1 - Sizewell C – The environment, coastal morphology and climate change-a 2020 perspective.

Nick Scarr. Nickscarr1@gmail.com, Nuclear Consulting Group, M.D. seismic and oceanographic engineering consultancy.

Sizewell C – The environment, coastal morphology and climate change-a 2020 perspective.

Chart: Changes in the position and shape of the Sizewell-Dunwich Banks between 1868 and 1992, based on Admiralty surveys.

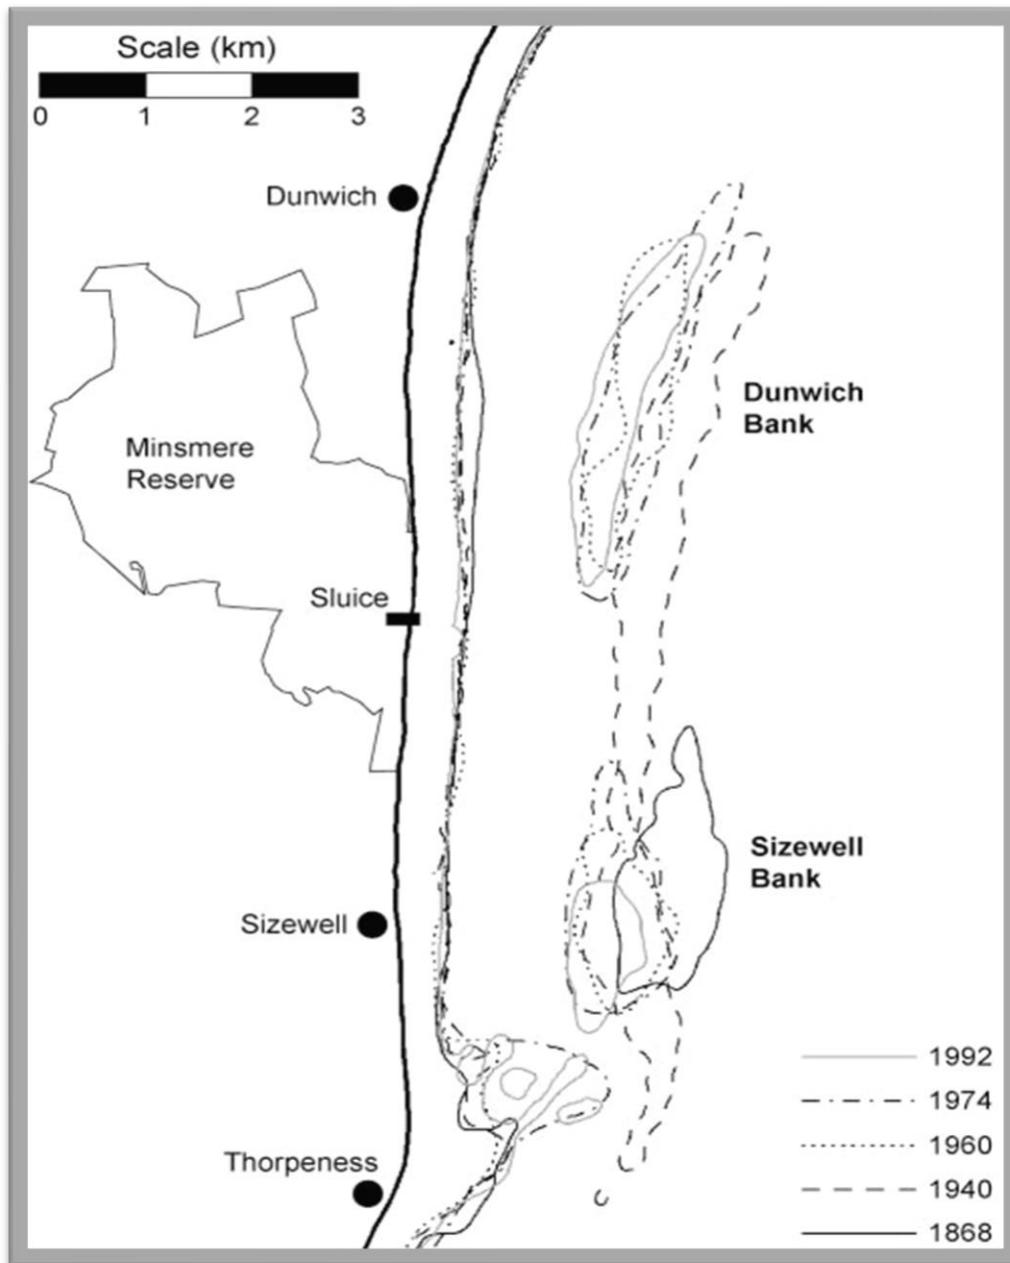
The Environment Agency is aware of the suggestion that median sea level rise could cause the Sizewell complex to become fully or partially surrounded by flood water. The likelihood of this is increased by the greater vulnerability of the Sizewell foreshore caused by rising median sea-levels introducing a threefold problem: storm surges can operate from a higher median baseline; the attenuation effects of the banks are reduced by deeper water allowing higher wave size and energies to reach the foreshore as described, and rising median sea level will have unknown effects on the geomorphology of the banks themselves. If 'islanding' of the Sizewell complex occurs in some form it will become subject to erosion. This clearly represents a significant risk. See: hydrographic chart, Appendix 1.

Hydrographic datasets show that there have been significant changes in the position, shape, and existence of the Sizewell-Dunwich banks between 1868 and 1992. As the security of Sizewell C needs to be established beyond doubt for a longer period than this (to at least the year 2150) the unconsolidated geology of these coralline banks clearly cannot be relied upon, the formation of a gap being potentially critical to the Sizewell foreshore. As median sea levels rise, the mitigating

Appendix 2 – EDF Stage 3 proposals showing proposed construction detail.

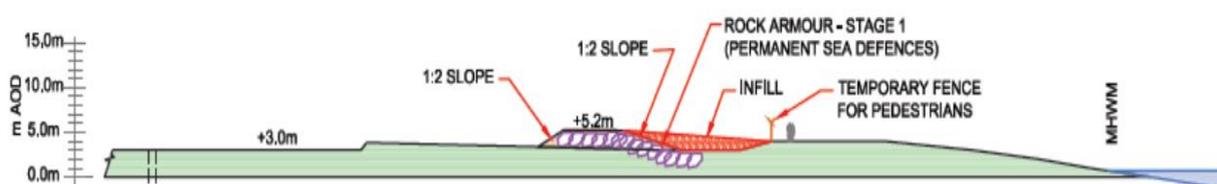
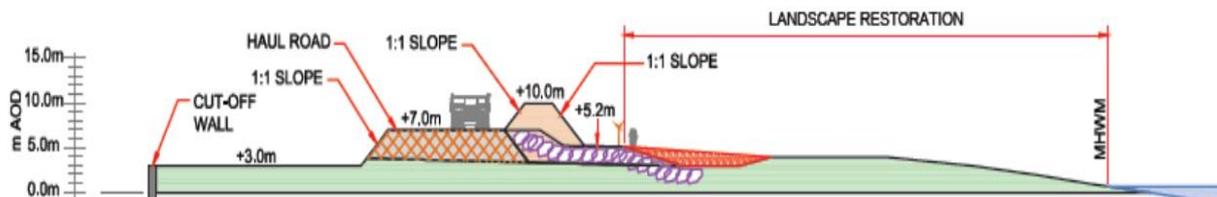
Note the lowest point of rock defence and the height of current MHWN. The reader can transpose the MHWM with the revised median sea level rises as forecast by UKCP18, the IPCC.

536. The Councils are concerned that the defences proposed are *not a complete design* and ...gives a *misleading impression* of the seaward extent of the hard-coastal defence feature (HCDF).

546 The Councils [note] *the risks and uncertainties associated with the HCDF* [hard coastal defence feature] *over its lifetime. Of particular concern is the lack of consideration of whole-life timescales*

when discussing potential impacts. Exposure of the HCDF [i.e. compromise] is recognised to potentially occur by mid operation life (assumed 2070). However, as the station lifetime to removal may be up to 2150, this implies 80 years of exposure causing increasing interference and requiring increasing mitigation.

569. The Councils [note] that the proposed footprint is further seaward than Sizewell B, which gives the Councils significant concerns around the impact on coastal processes and coastline and may *make this design unacceptable.*

Simplified geological map of the land between Walberswick and Thorpeness (Source: BEEMS, 2012).
Mott Mac., op.cit., p 20-21.

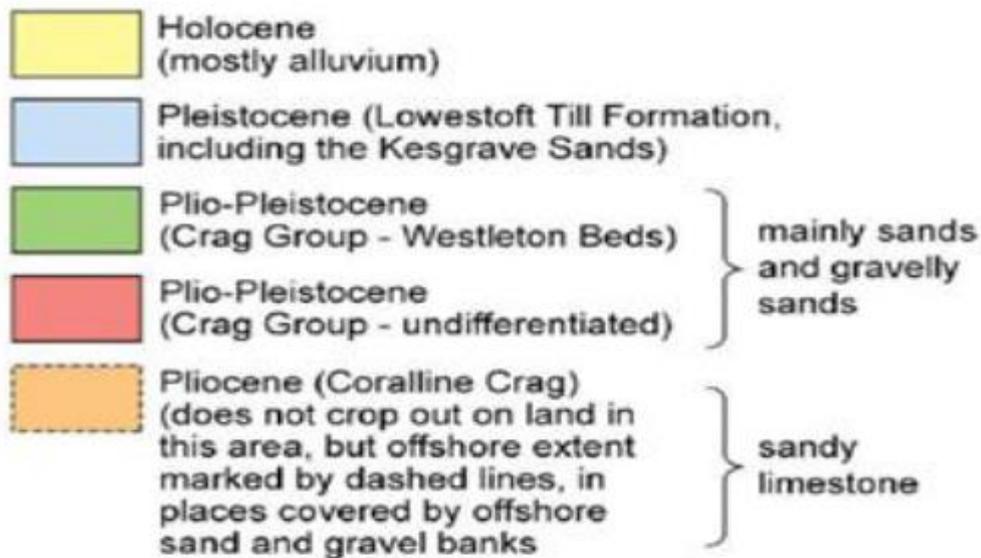
Note that the map is not to scale, and that Sizewell C is a two-reactor complex larger than A and B together. The Northern extent of Sizewell C would be halfway to the sluice. Page 31 is an OS map showing the extent of the complex.

Note the position of Sizewell C on Holocene alluvium.
